Our Ref T22- 000
Your Ref: 20032138 Rep 119/Rep 120
3 April 2023

A66 Trans-Pennine Project Scheme 0102 – M6 Junction 40 to Kemplay Bank

Mis-labelled Drawings

Drawing Title
**M6 Junction 40
 Typical Sections
 (CH 450 & CH 9666)
 Sheet 1 of 1**

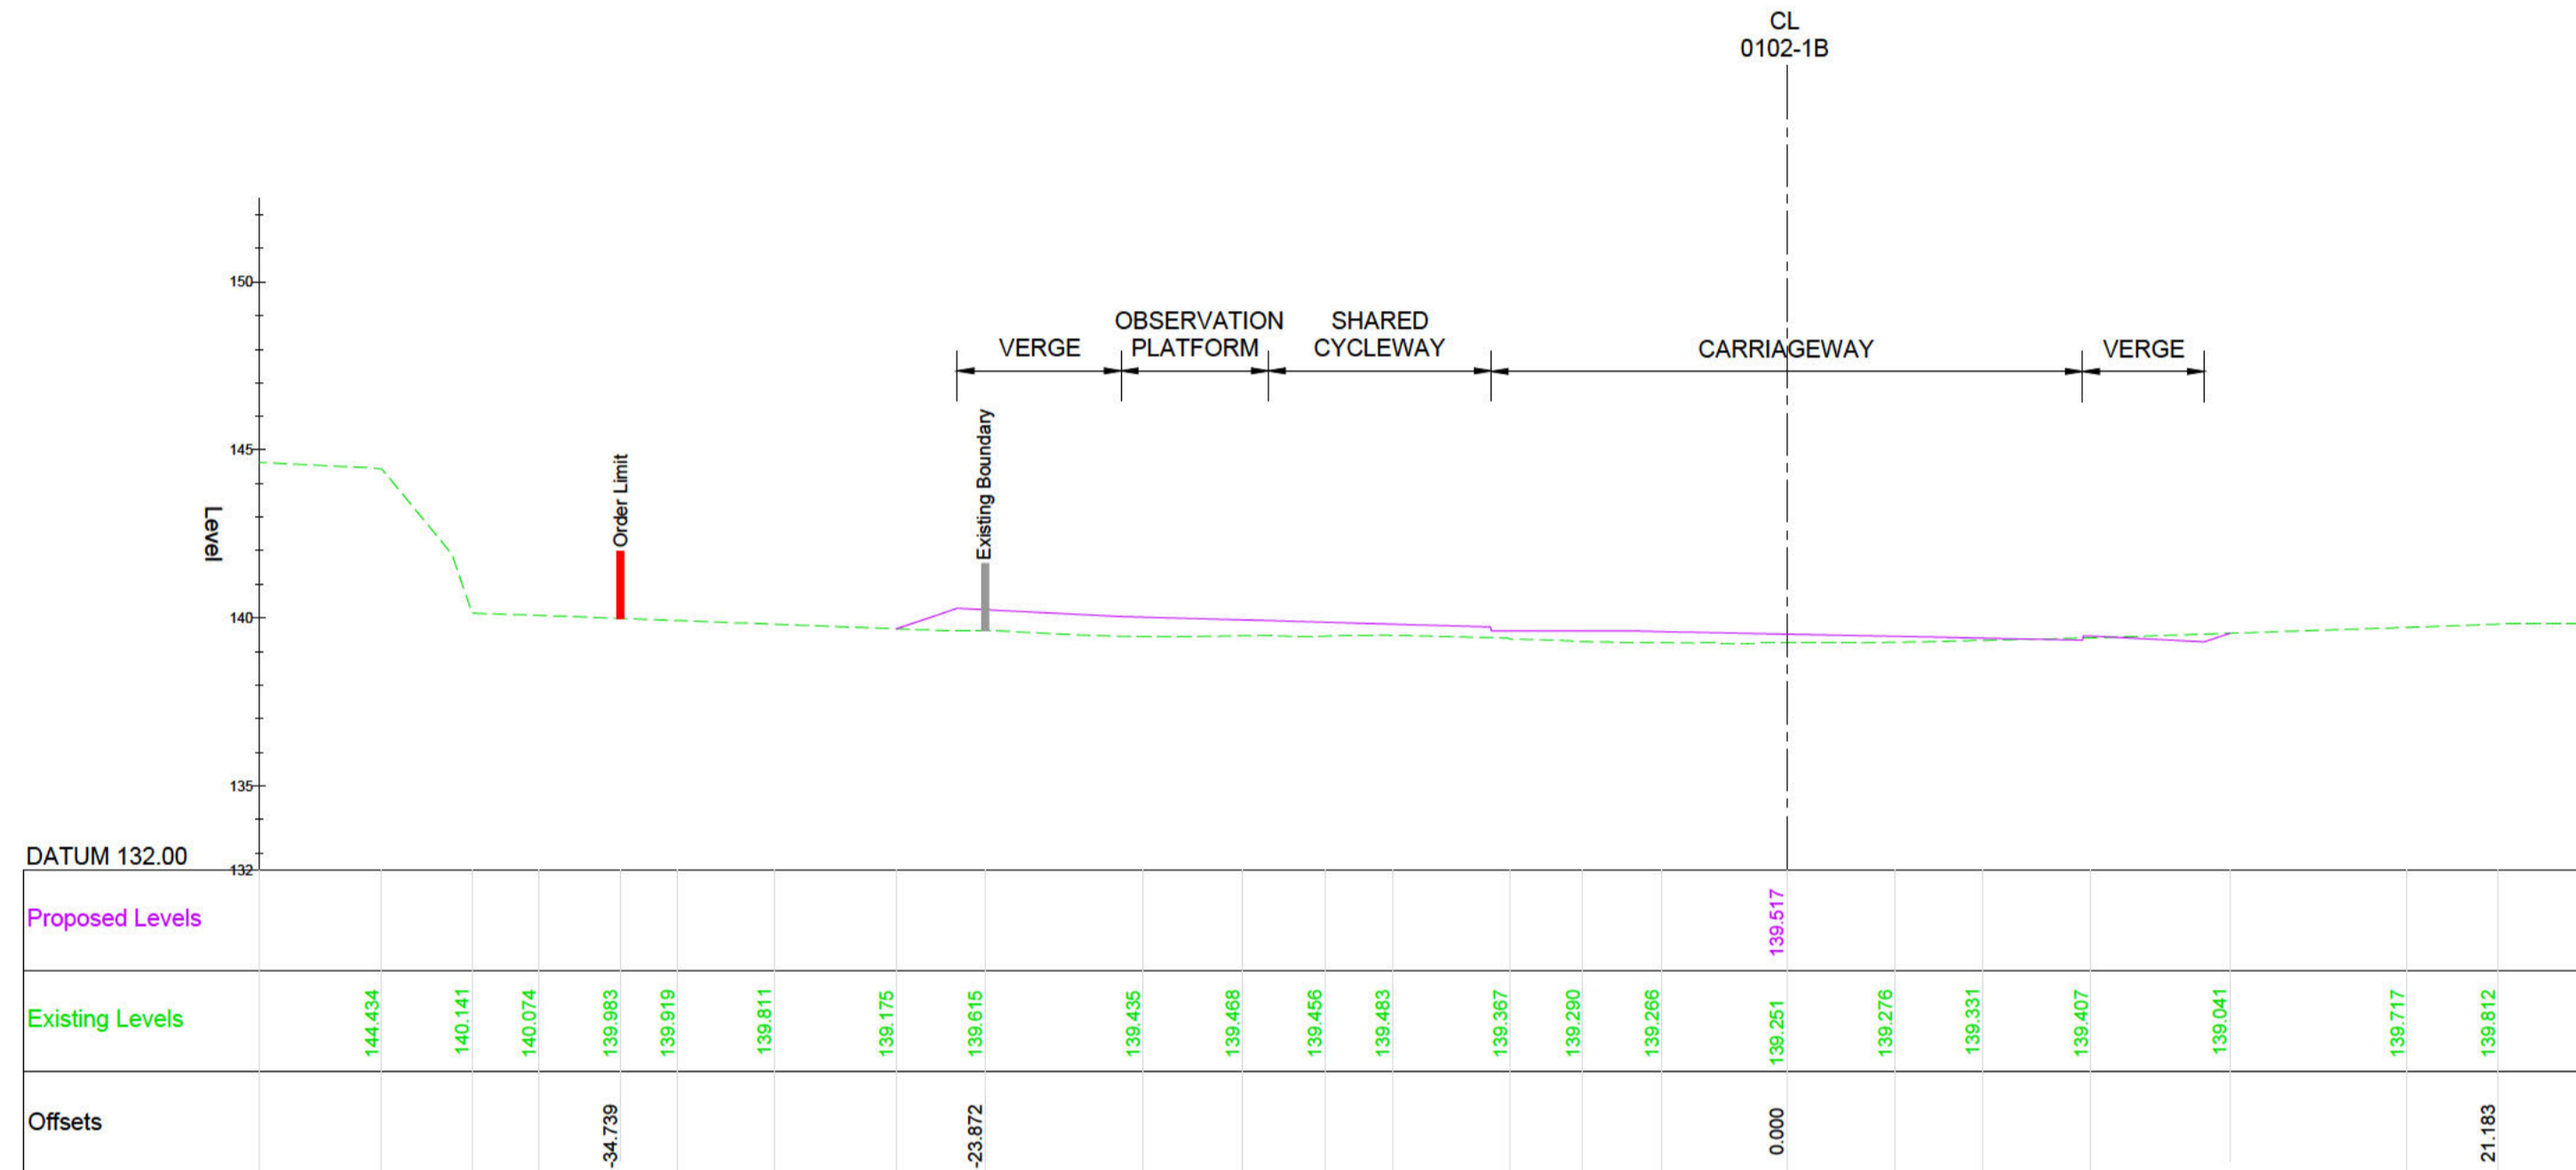
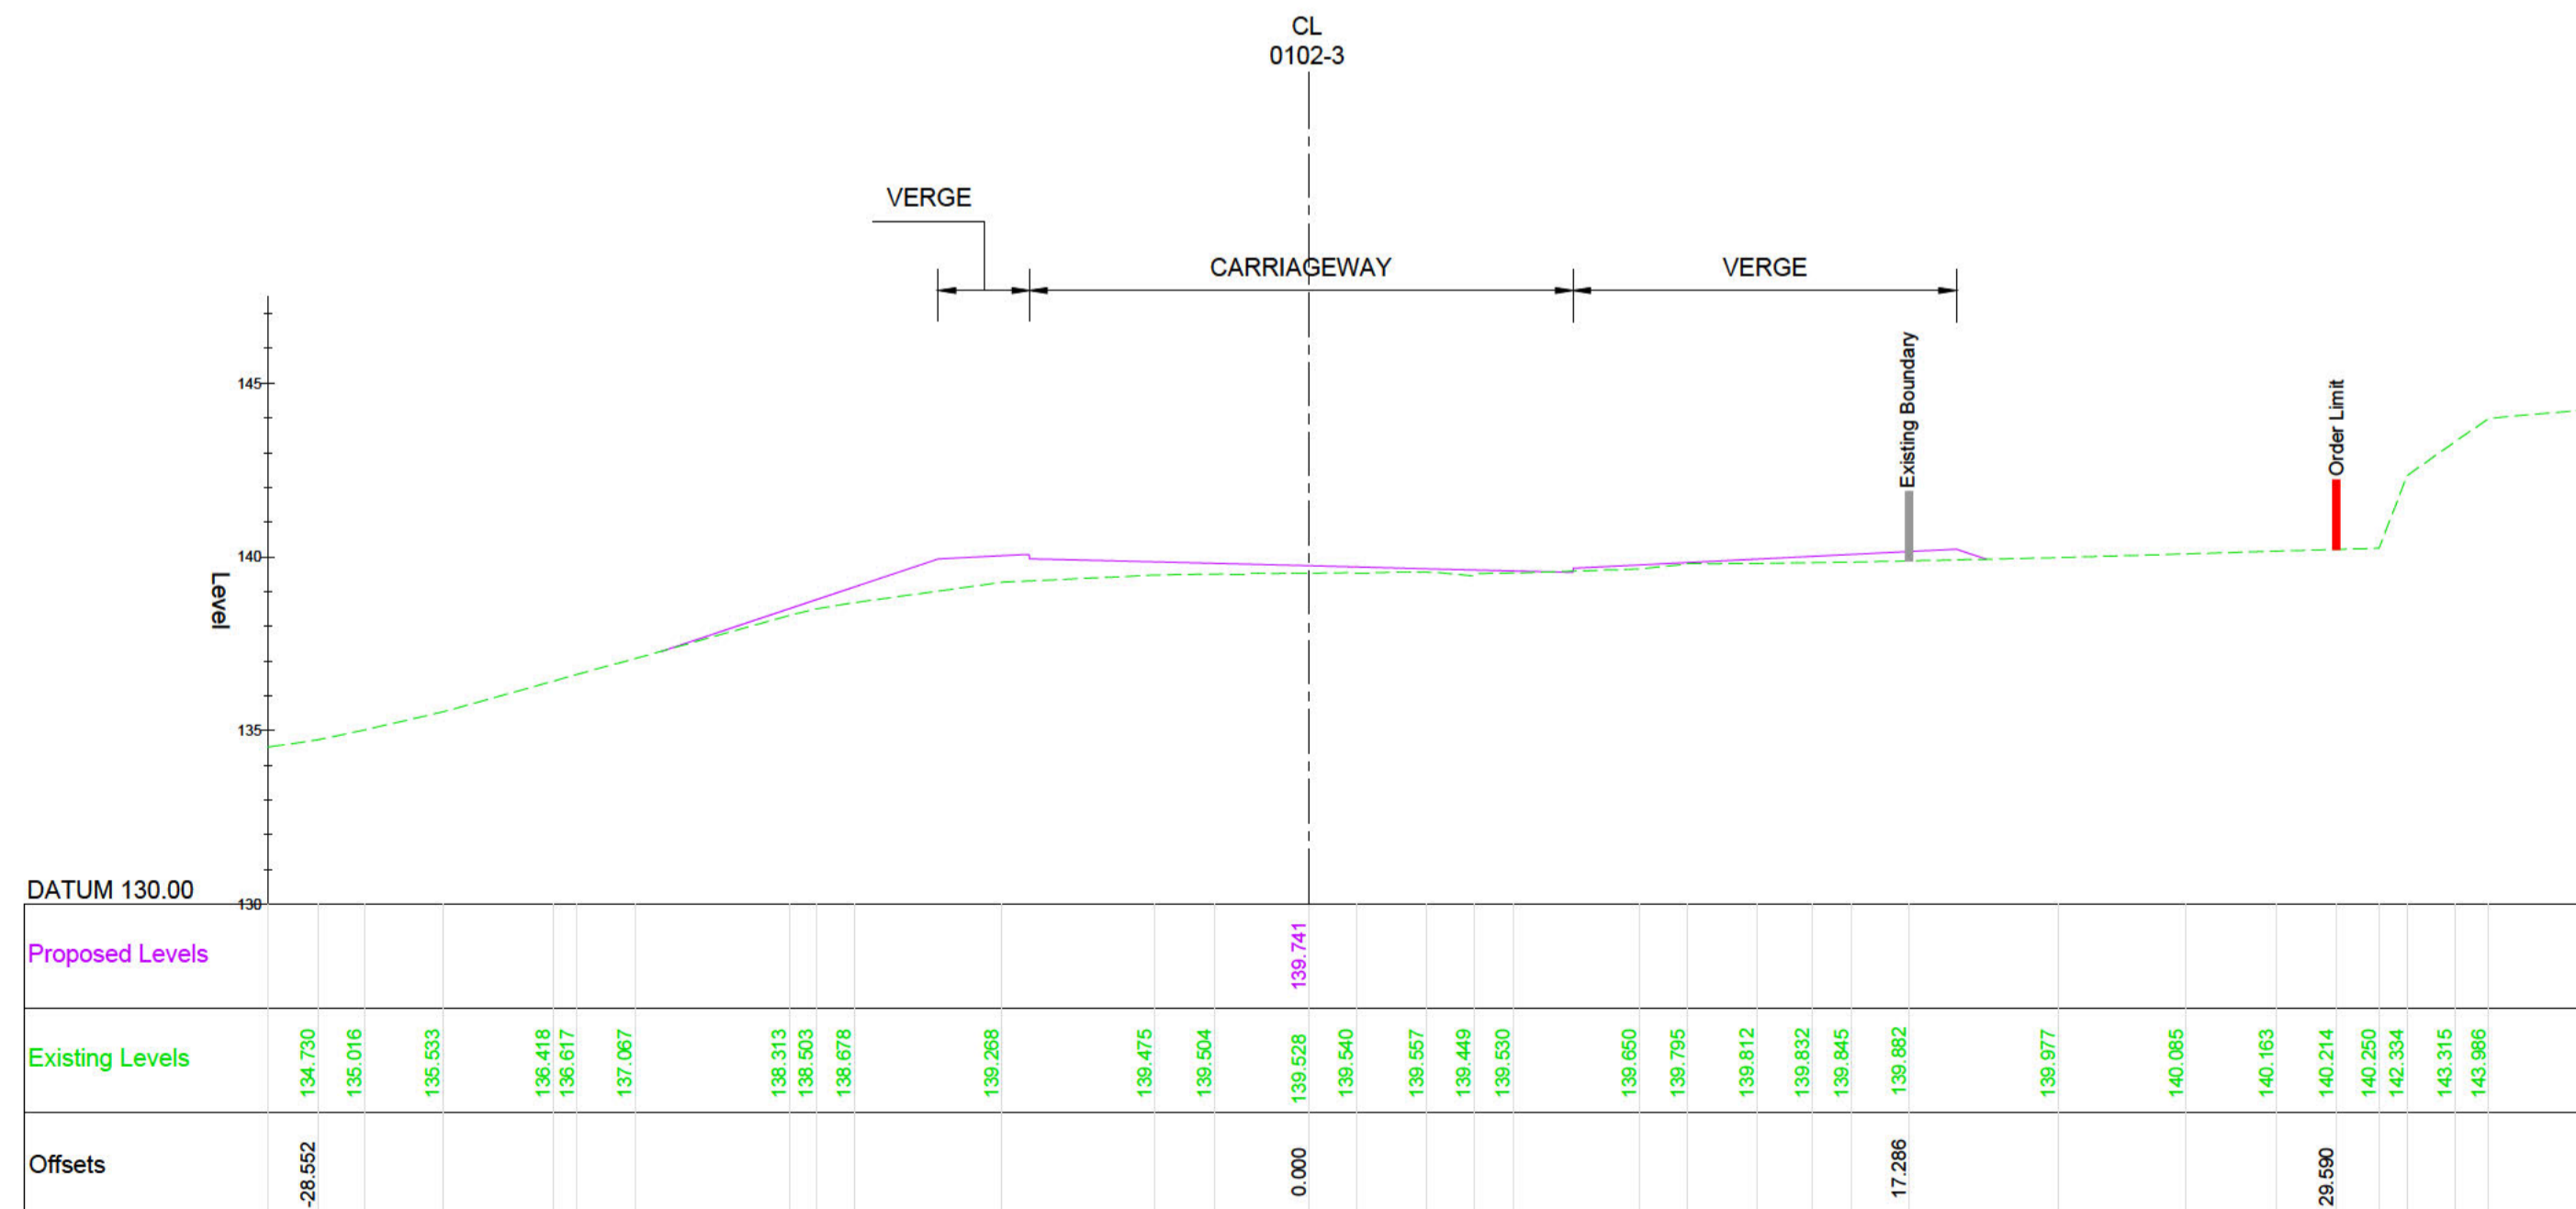
The cross sectional drawings in document 7.30 appendix G, provided by the Applicant misrepresent the existing ground levels of the order land in these locations and are therefore misleading in demonstrating the works being required in the context of land to the extent of order limits which implies the ground raises beyond the Order Limits or the relative elevated positioning of the existing ground level at the Order Limits in relation to the verge land or road surface that are within the National Highways existing ownership.

The nature of the land proposed to be taken is mischaracterised as being as being on relatively level land between the existing highway boundary and the Order Limit whereas the reality is that the Order Limit land take is to the top of the slope which rises from the Existing Boundary to the highway, up to the relatively level land on which Ghyll Mount sits; the top of the slope is the Order Limit per the sketch attached at appendix xx.

For the cross section drawings of works 0102-3 and 0102-1b demonstrate that the minor levels changes required can be accommodated within existing highway verge or verge/observation/shared cycleway of approximately 9.5m and 15m respectively and therefore there is no need to acquire Plot 0102-01-20.

The Applicant was asked for cross sectional drawings across 0102-3, 0102-1b and 0102-4 to justify the acquisition of the land in plot 0102-01-20. While the inaccurate drawings for works section 0102-3 and 0102-1b have been provided a cross sectional drawing across Works No 0102-4 has not been provided.

Drawing Title: Works Plans, Regulation 5(2)(j), Sheet 1 of 2

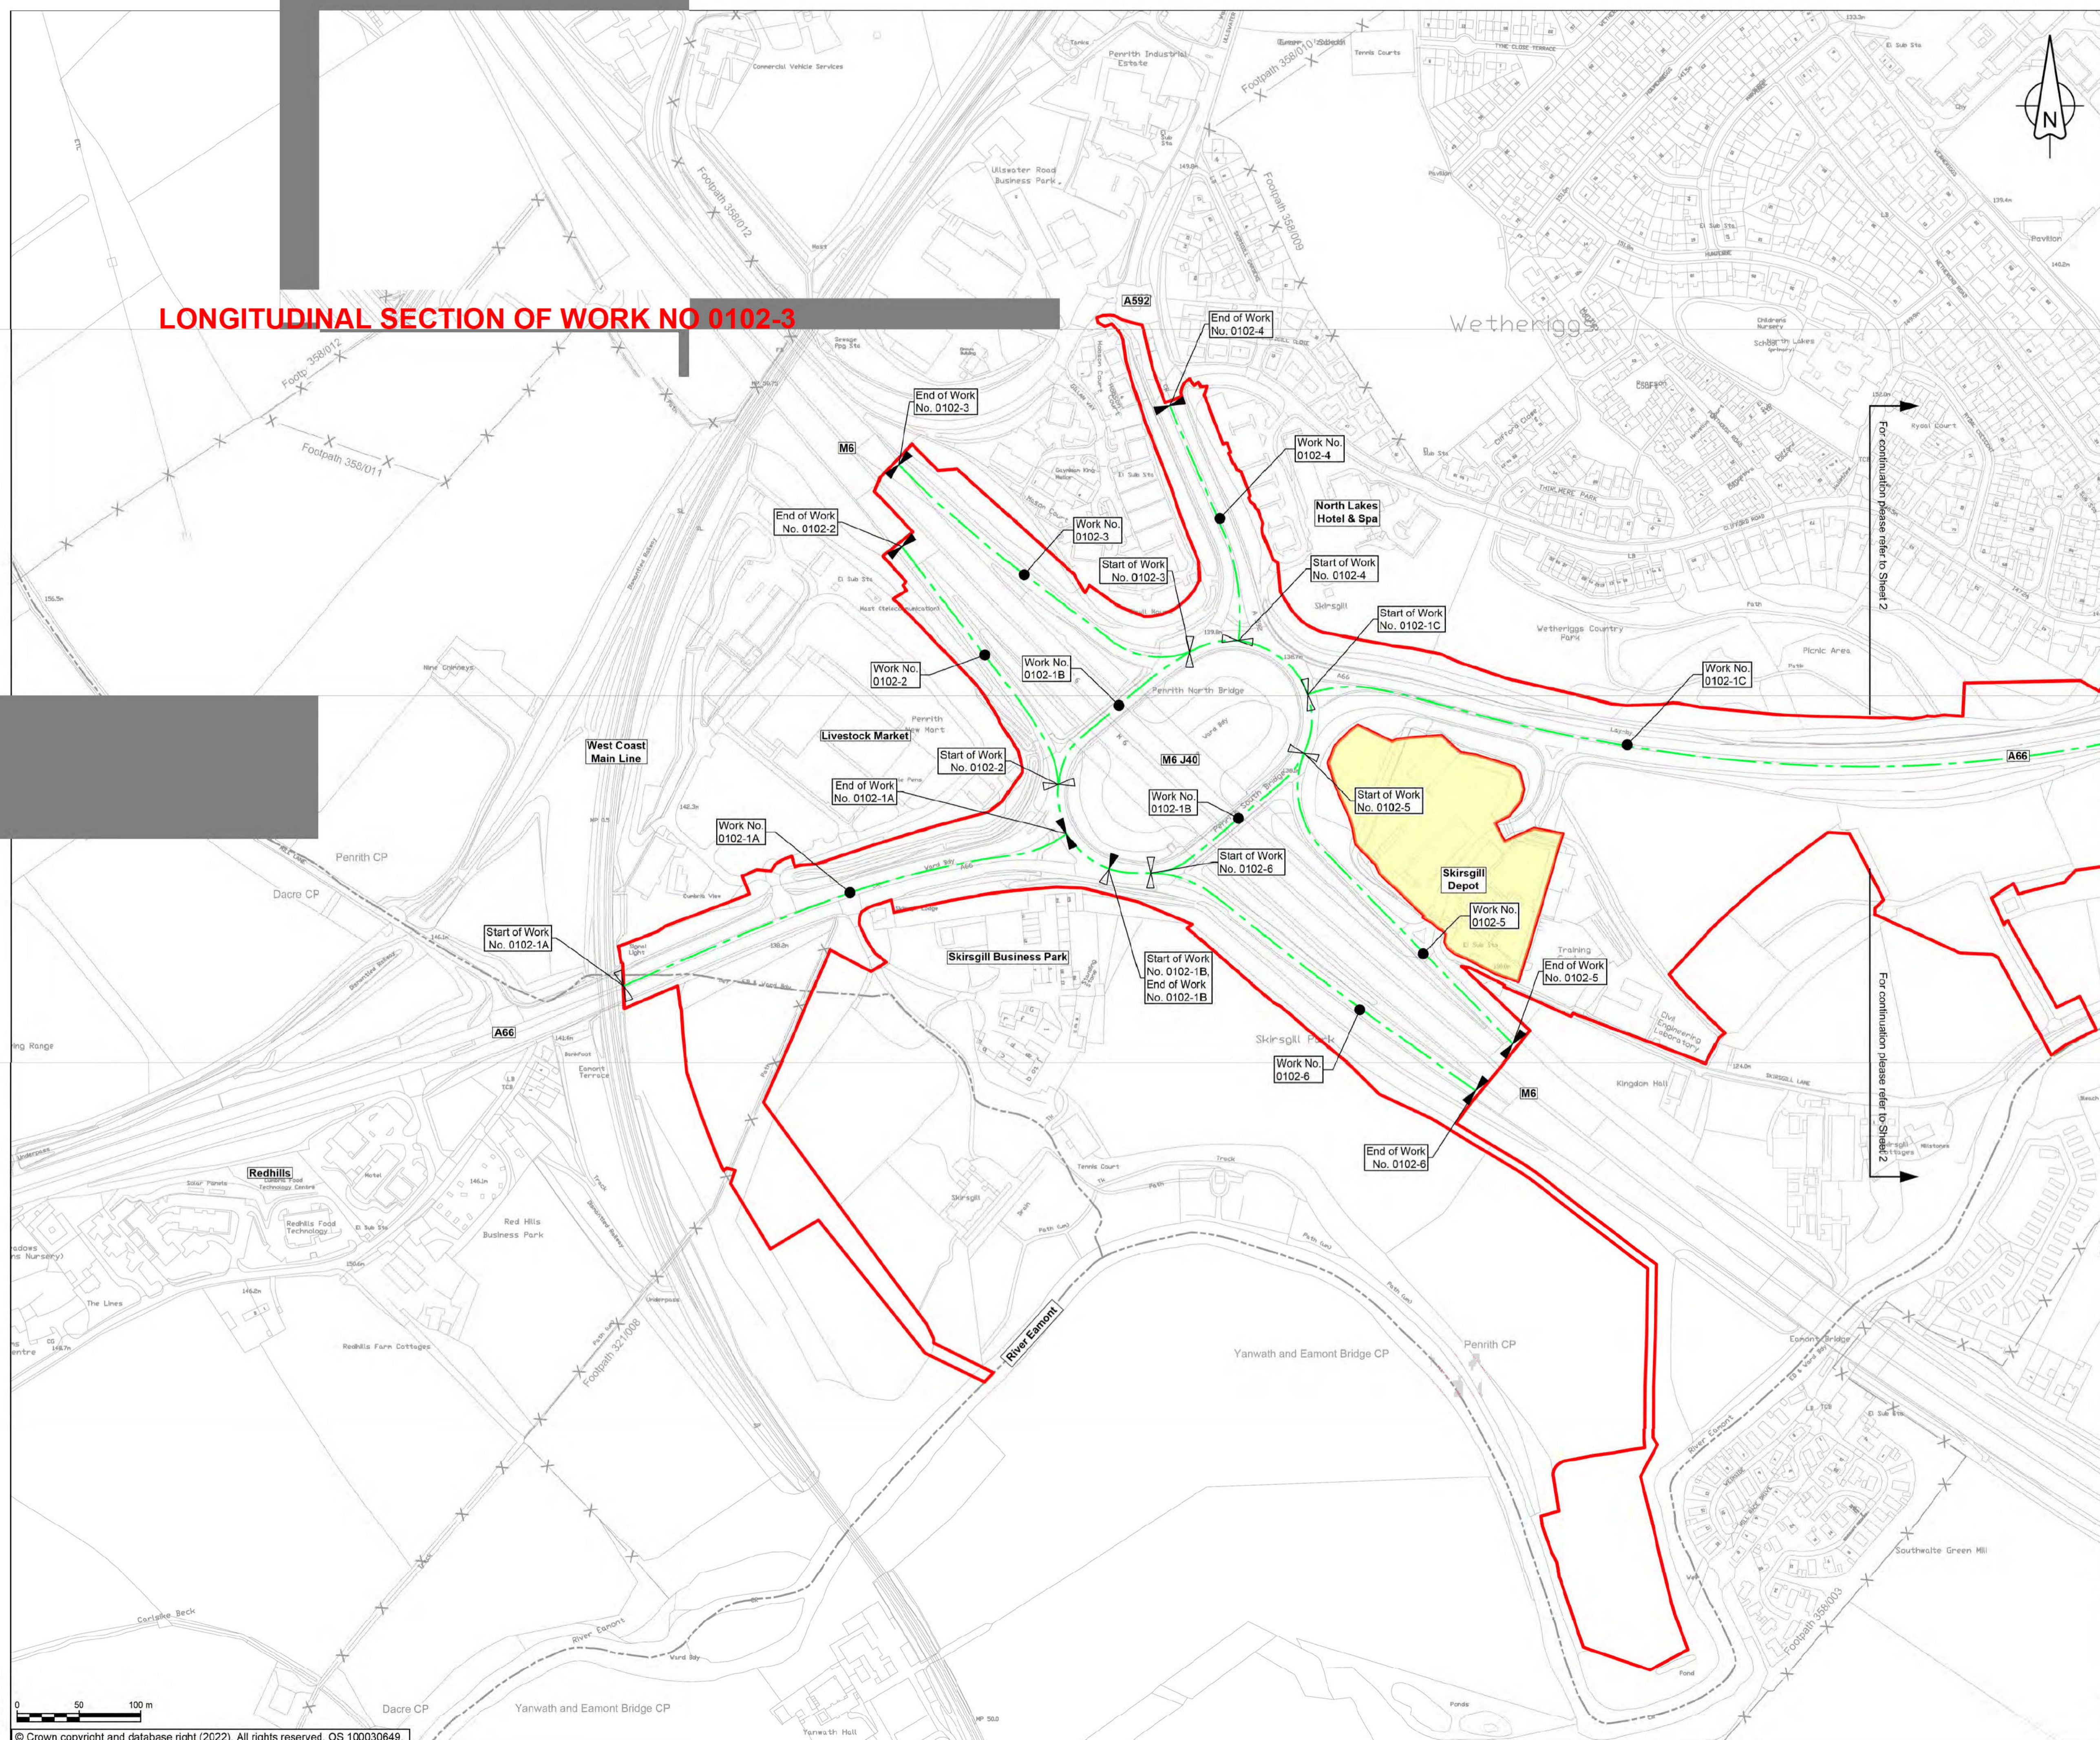
With regard to the longitudinal section to 0102-3. If Document 5.17 is the same as "Doc App-326 Engineering Section Drawings (Plan and Profiles) as part of the DCO submission" and Sheet 3 of 6 drawing "A592 Northbound to M6 Southbound Diverge" is being identified as the relevant drawing that includes Works No 0102-3, then the labelling is incorrect or it does not show the profile of Work No 0102-3. The description given in the drawing title is for works numbers 0102-4 and 0102-1A – which are for the A592 Northbound and the A66 Westbound from the roundabout.

An accurate longitudinal section for the description of the work packages for M6 Southbound to A592 Northbound should show Works No Works No 0102-3, a short section of Works Nos 0102-1B and 0102-4.

- a) The labelling of the sections in document 5.17 Engineering Section drawings (Plan and Profile) are difficult to reconcile because the cross sections on page 4 of the document (sheet 3 of 6, drawing reference 001002) indicate that section 0102-4 is contiguous with sections 0102-1A and section 0102-1C which they are not on the identification plan. Longitudinal Section drawings for 0102-3 are not given.

- d) The longitudinal section of works 0102-3 have not been presented in 5.17. The Applicant has confirmed this will be presented to the Examining Authority at Deadline 5. It is assumed that the existing slip road levels will be broadly maintained or if altered only altered in a minor form and therefore it is anticipated that any minor levels changes can similarly be accommodated within the existing National Highways land which is currently in excess of 11 metres wide to kerb of carriageway. This is demonstrated in the Cross sections in Doc 7.30.
